July 21, 2015

RE: Amendment to CMD response to comments
Refined Metals Corporation – Beech Grove, Indiana
IND 000 718 130

Refined Metals Corporation (RMC) and Advanced GeoServices Corp. (Advanced GeoServices) have reviewed your comments received (via email) on June 26, 2015, pertaining to the condition approval of the Amendments to the Corrective Measures Design (CMD) for the former RMC facility located in Beech Grove, Indiana. These comments were further discussed on a conference call with you on July 1, 2015. All parties agreed that comments should not delay the Explanation of Significant Differences (ESD) process, and that addressing them would be a condition of the ESD. During that call Advanced GeoServices agreed with several of the comments and proposed that this be documented in a response.

CORRECTED DRAWINGS
DA-01 and DA-02

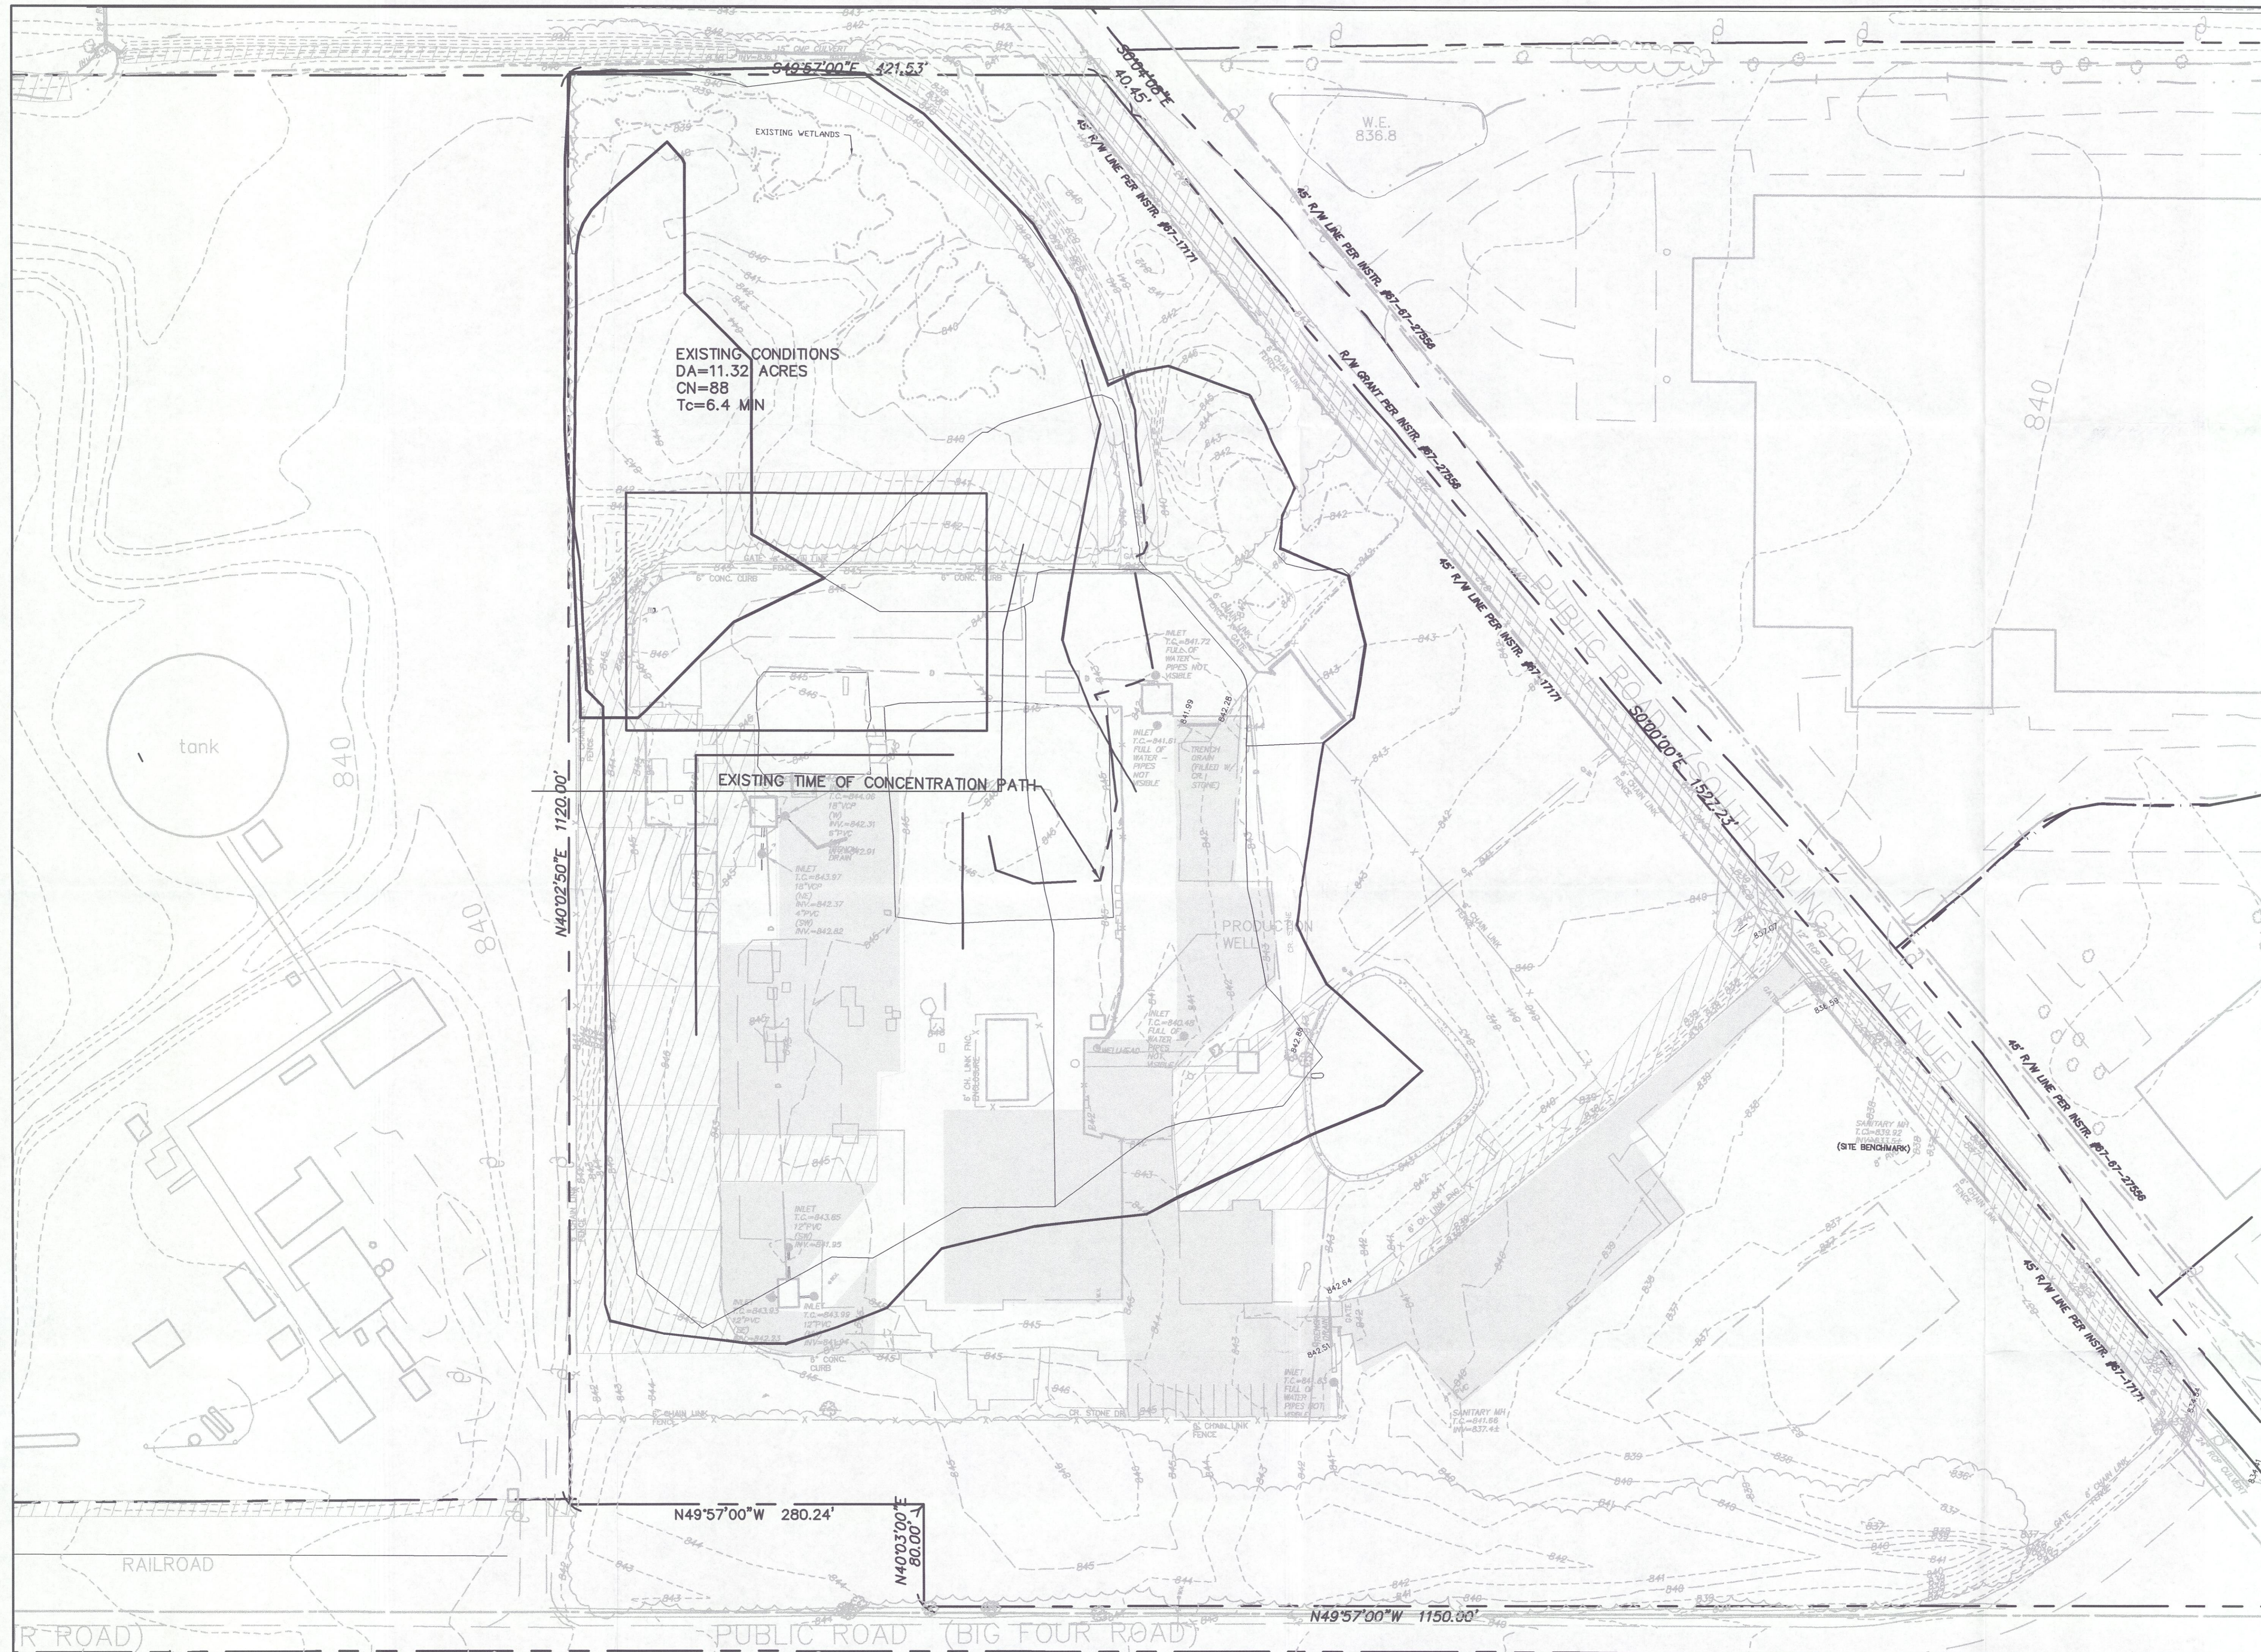
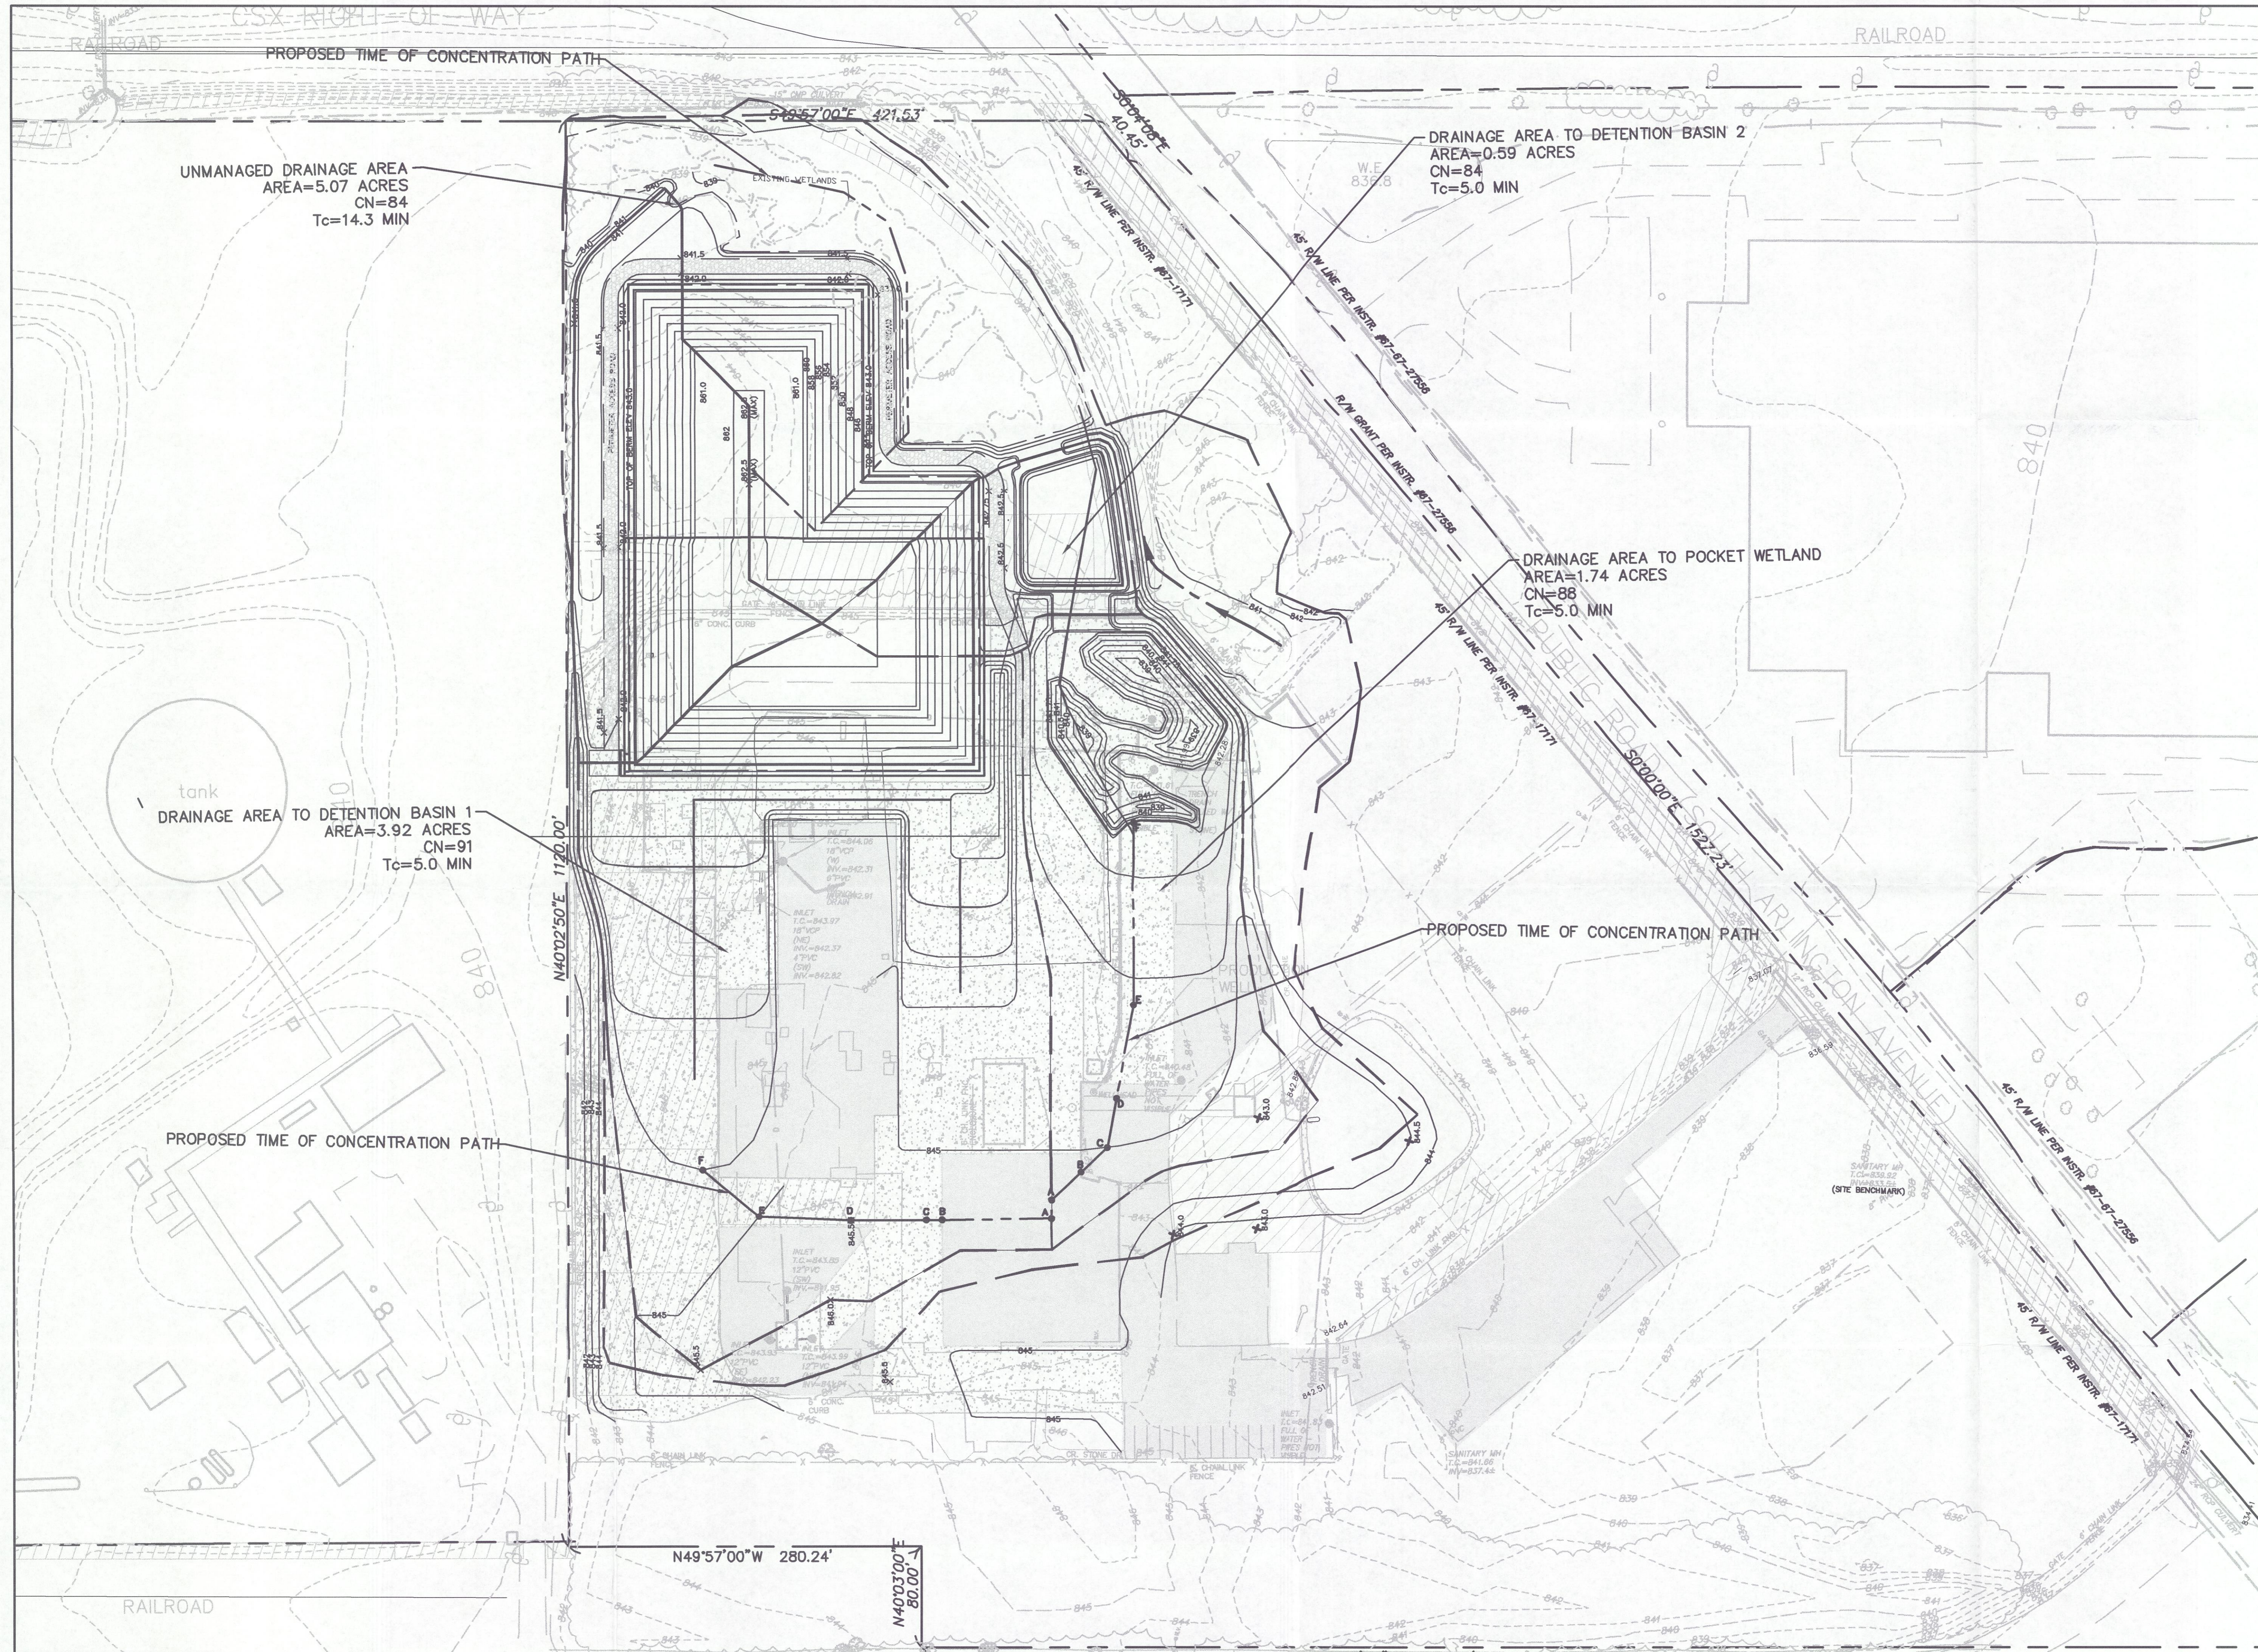
Comment 1: A review of the Stormwater calculations could not be completed because the drainage areas are inconsistent throughout document and this parameter has an effect on almost all of the calculations. The drainage area of the project site was documented previously as 11.2 acres. Figure DA-02 shows three drainage areas which total 11.2 acres. However, the HydroCAD calculations show four drainage areas which total 10.25 acres. The drainage area used in the water quality volume also does not match DA-02 or the areas used in the HydroCAD calculations. The drainage areas should be consistent in all calculations and match previous project total drainage areas. The HydroCAD calculations refer to a fourth subcatchment, 9S. Provide a revised drainage diagram which includes 9S.

Response: We apologize for any confusion that these discrepancies may have resulted in. Additional review of the calculations and drawings was performed to ensure consistency. Drawing DA-01, Drawing DA-02 and the HydroCAD calculations have been revised to show a total drainage area (existing and proposed) of 11.32 acres. The unmanaged area has been revised from 4.00 acres to be 5.07 acres, which corrects the discrepancy noted between the drainage areas in the June submission. Additionally the water quality calculations and the HydroCAD diagram have been revised. A revised Section 10 of the CMD is provided as a summary of the proposed post-CCB construction conditions. The corrected support documents are attached and include drawings (DA-01 and DA-02), calculation sheets (water quality volume), and the HydroCAD reports.
